Platt Technical High School

ADDENDUM NO. 4

August 9, 2019

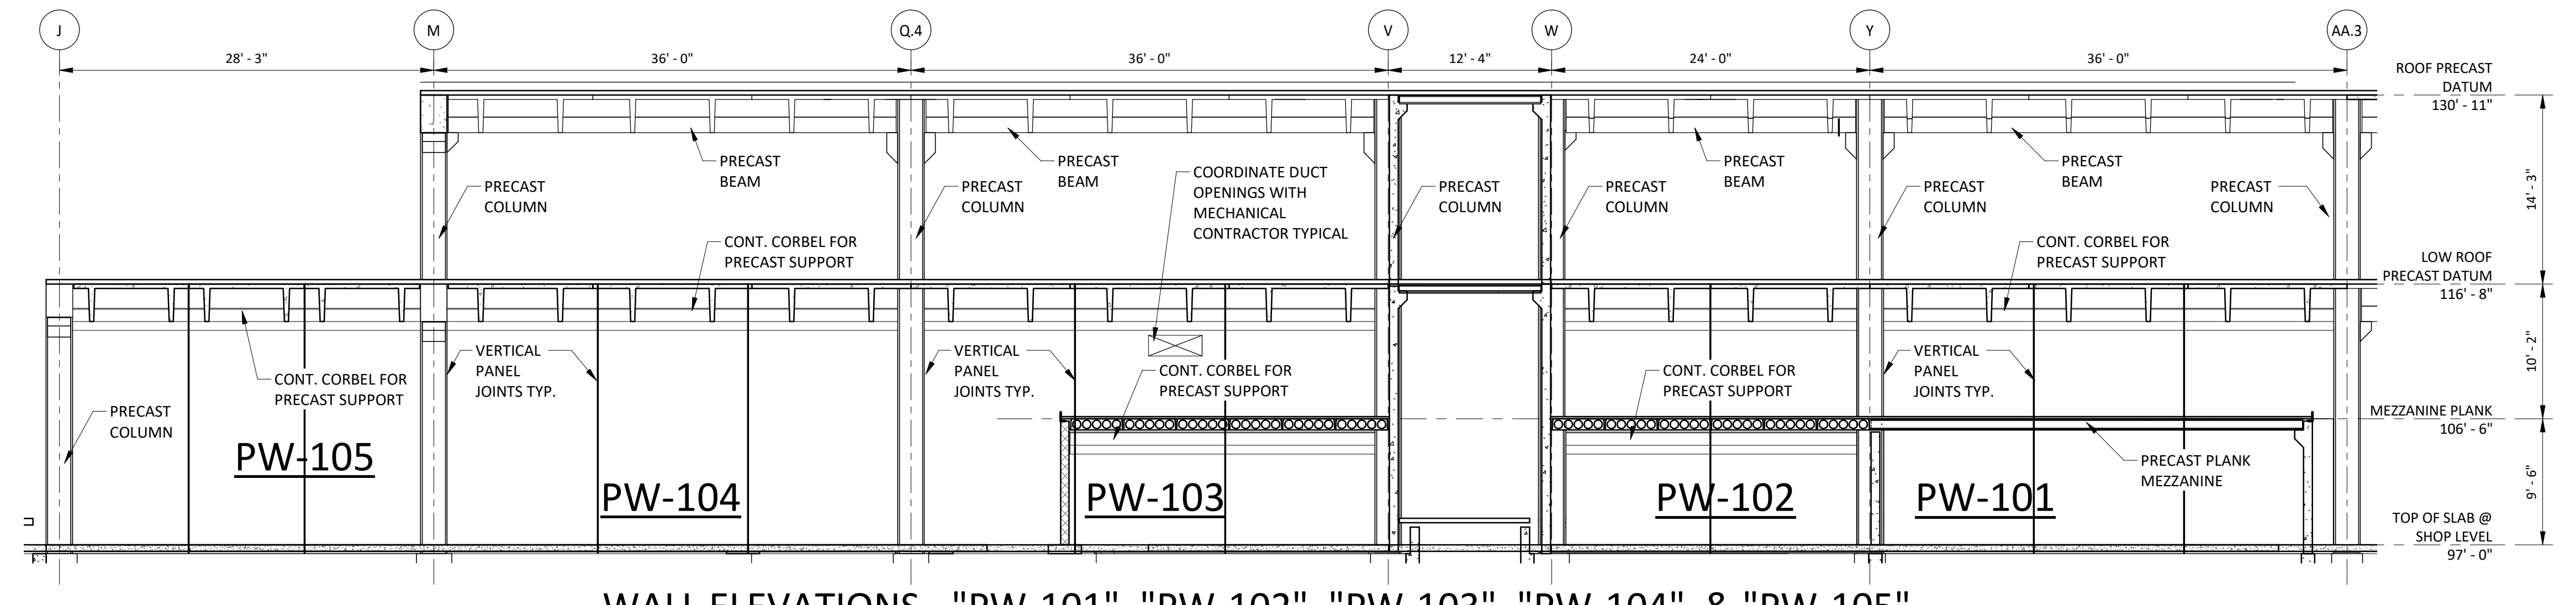
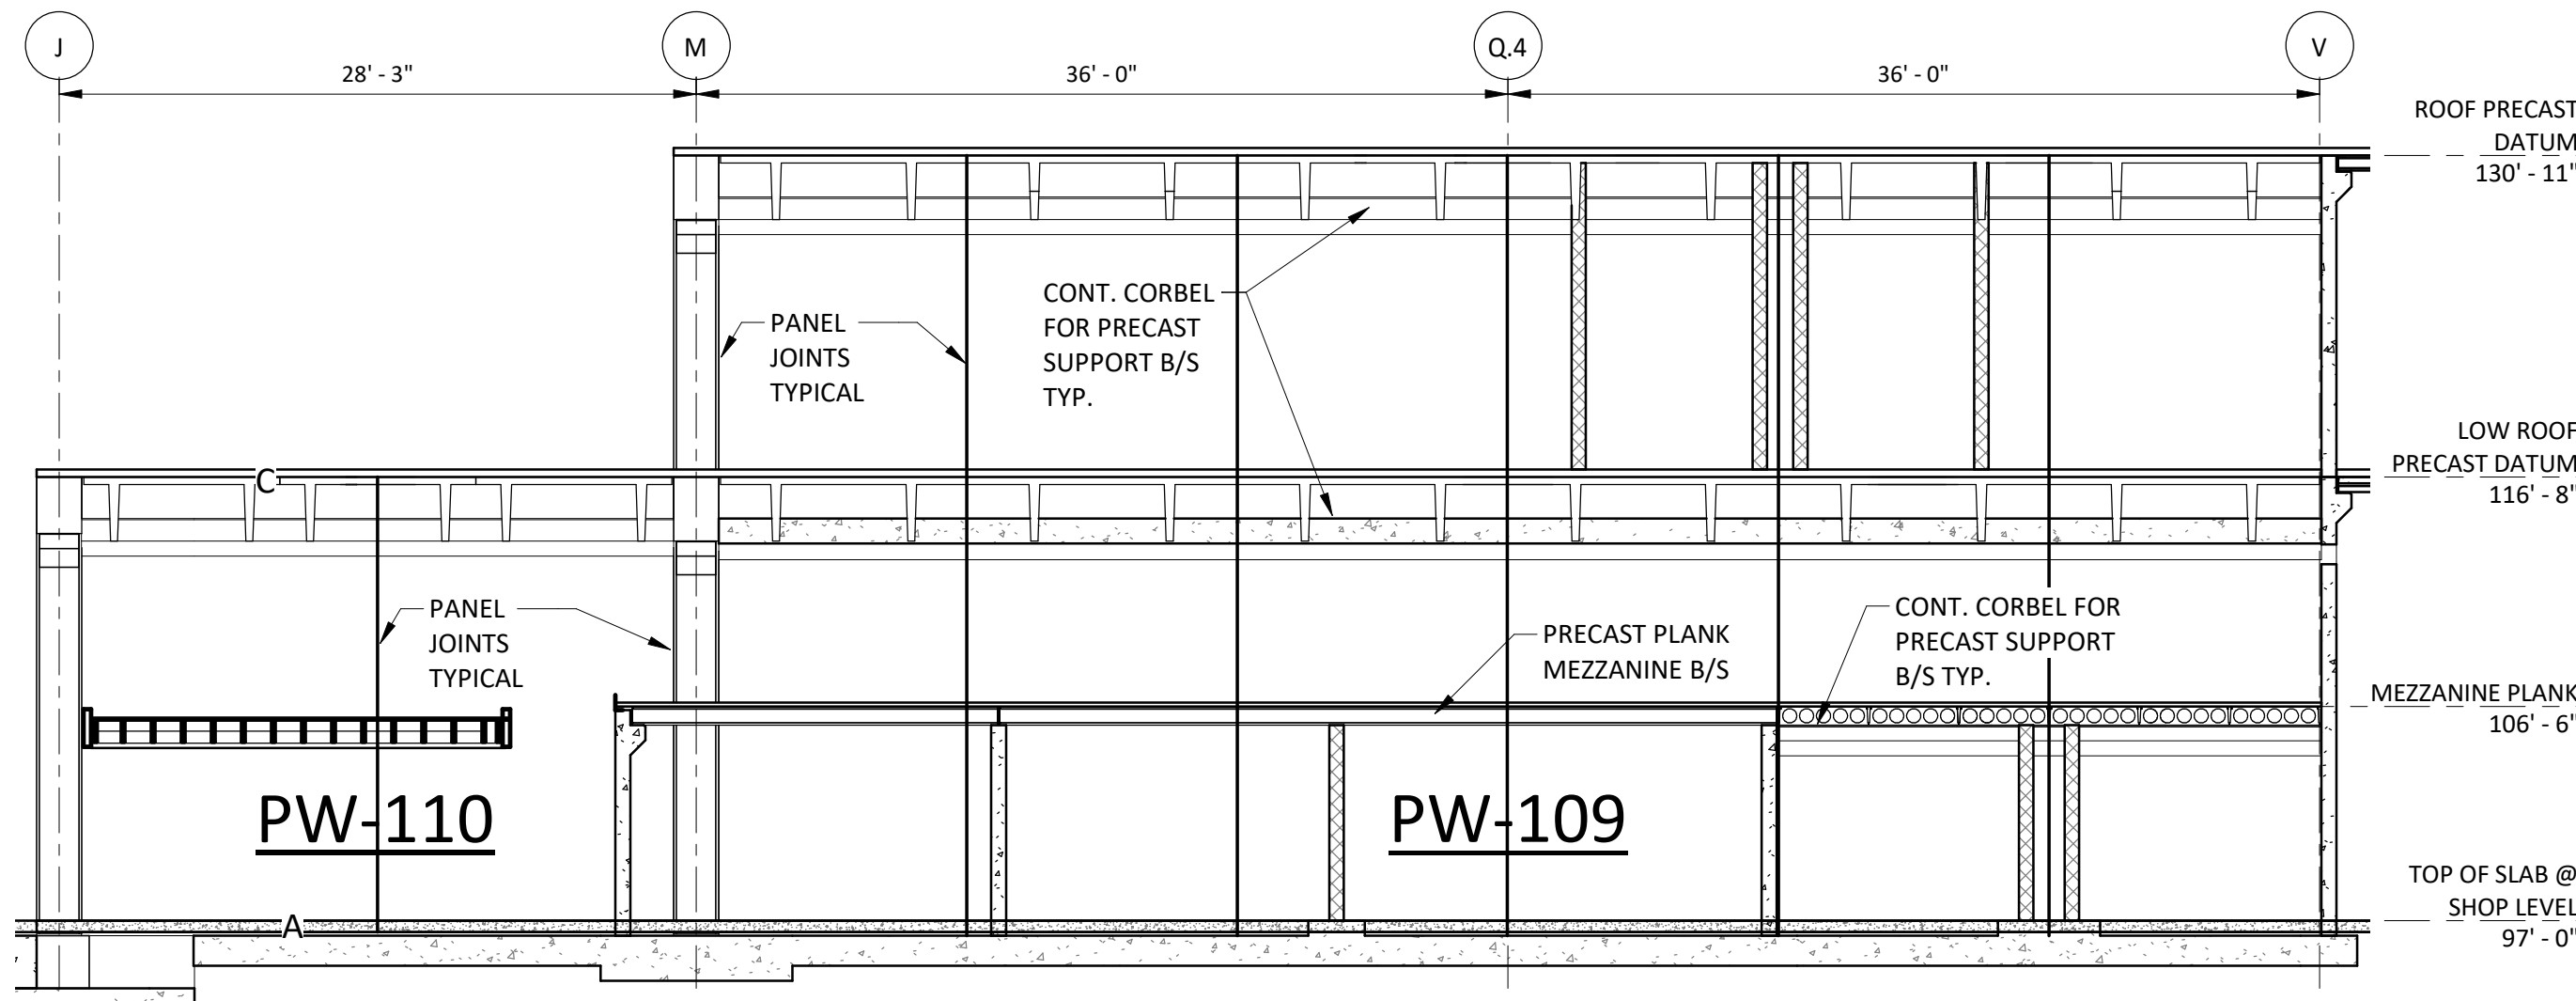
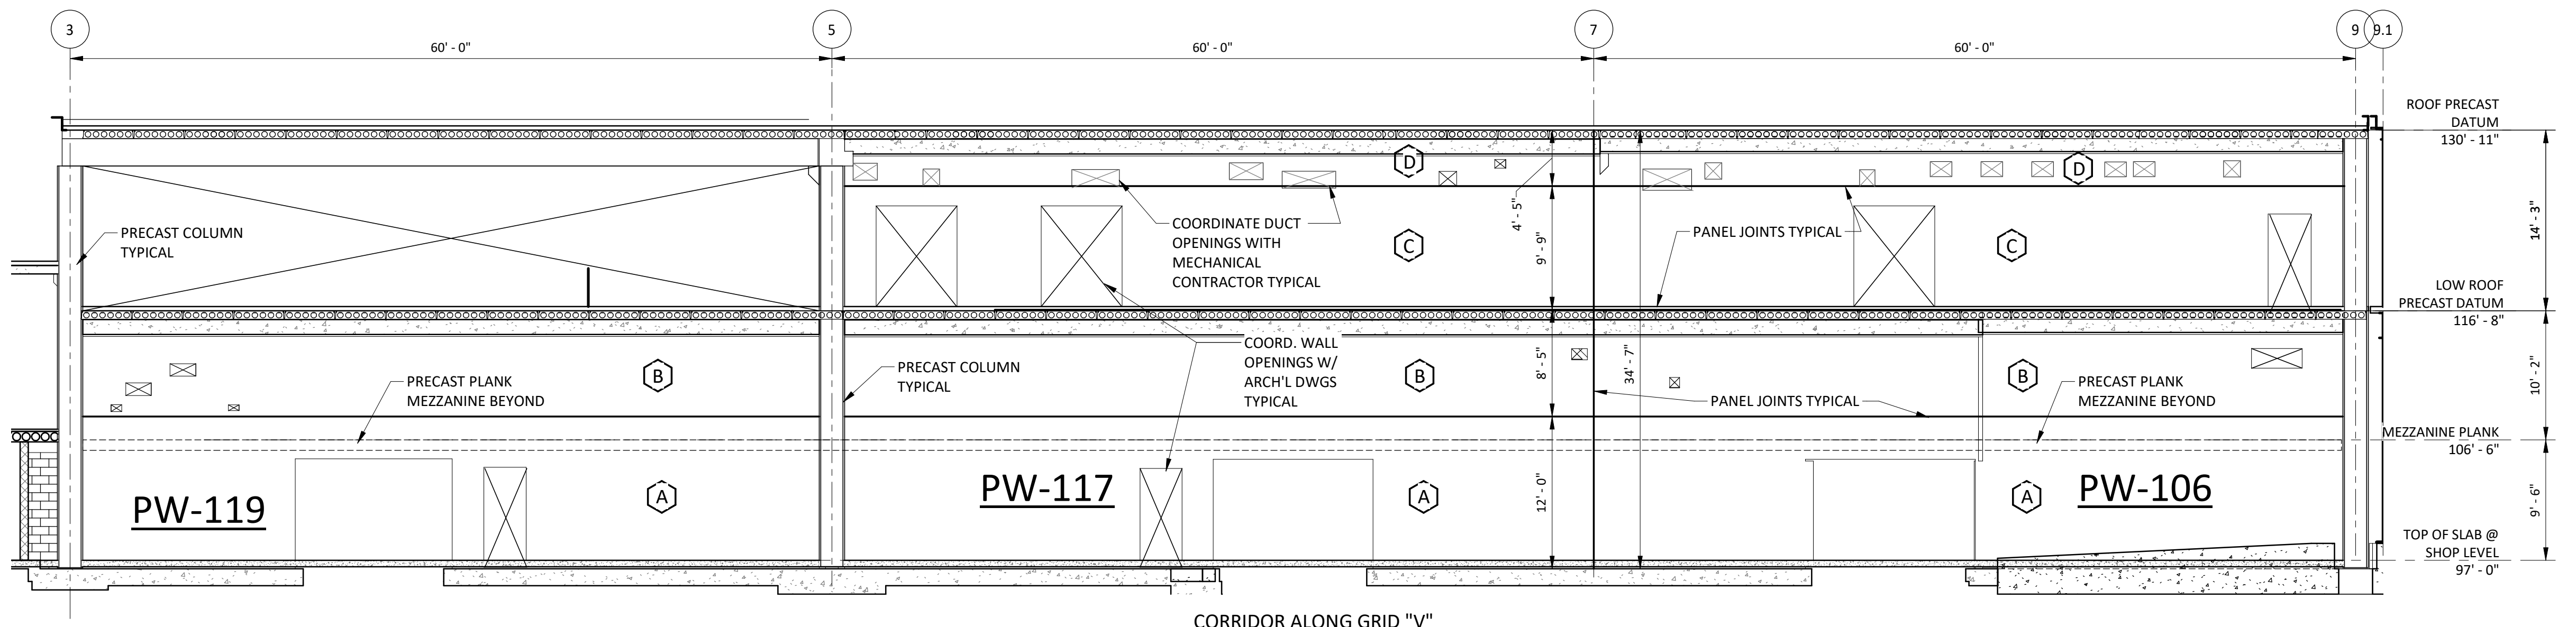
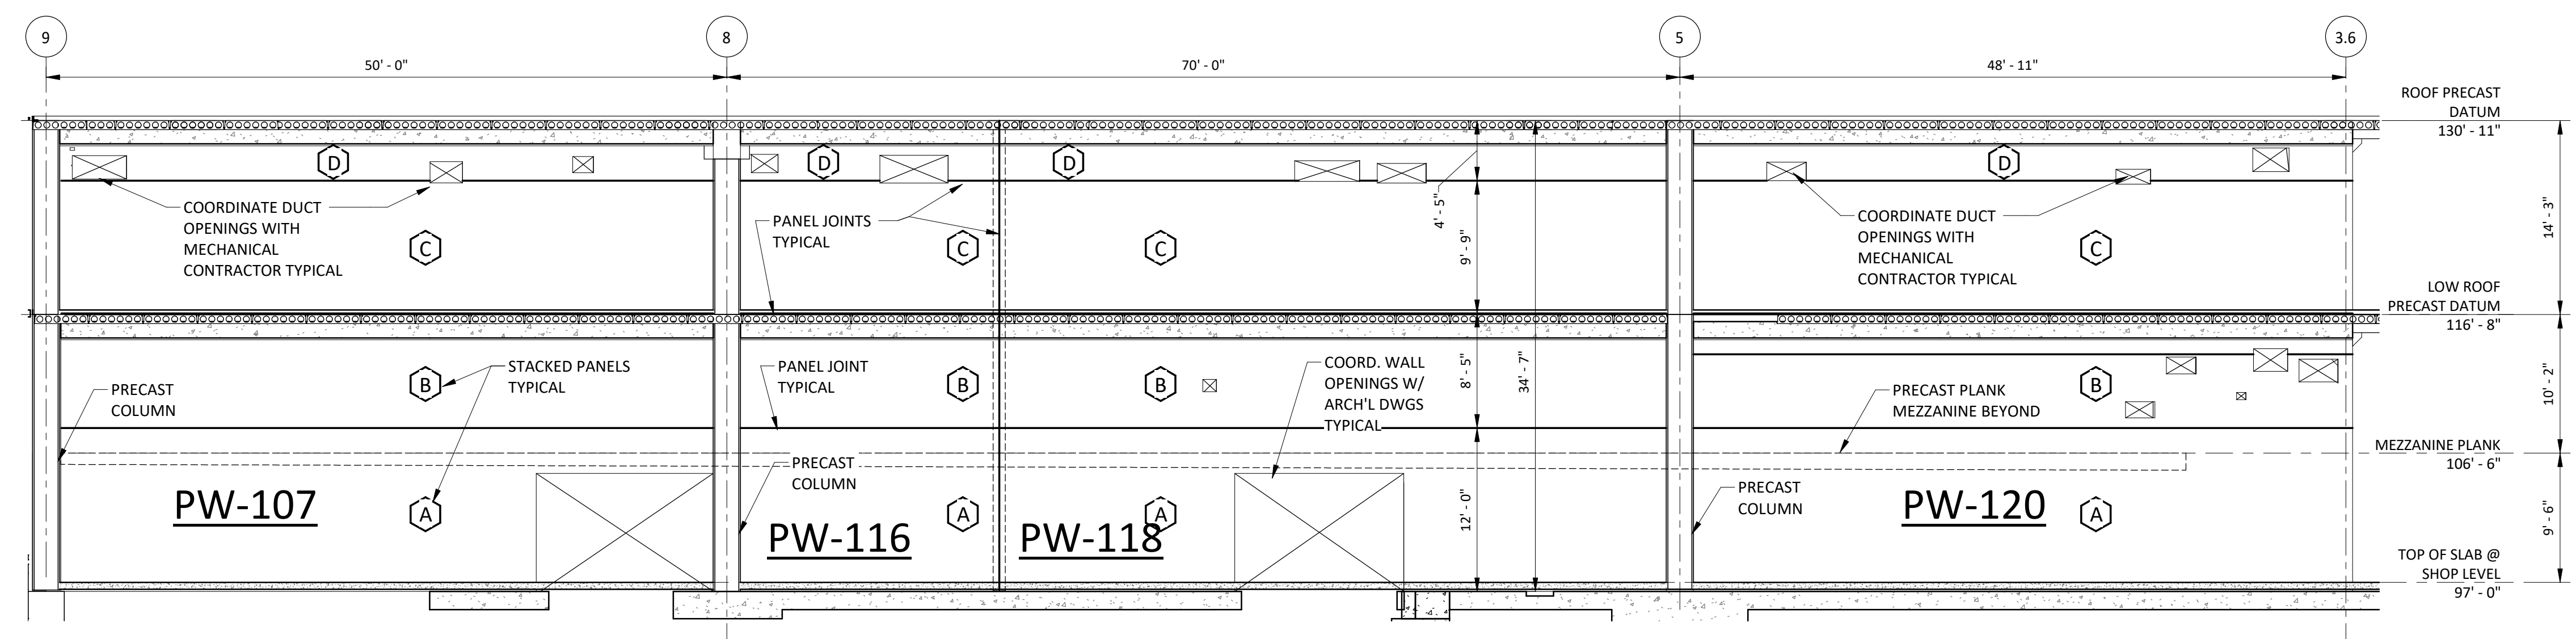
- ADD 4-120 DRAWING S2-3-1 – PRECAST WALL ELEVATIONS**
Added location notes per Revision RS4-32.
Added plan notes per Revision RS4-33.
- ADD 4-121 DRAWING S2-3-2 – PRECAST WALL ELEVATIONS**
Added wall elevations for stair #5 and mezzanine precast walls per Revision RS4-34.
Added plan notes per Revision RS4-35.
Added location notes per Revision RS4-36.
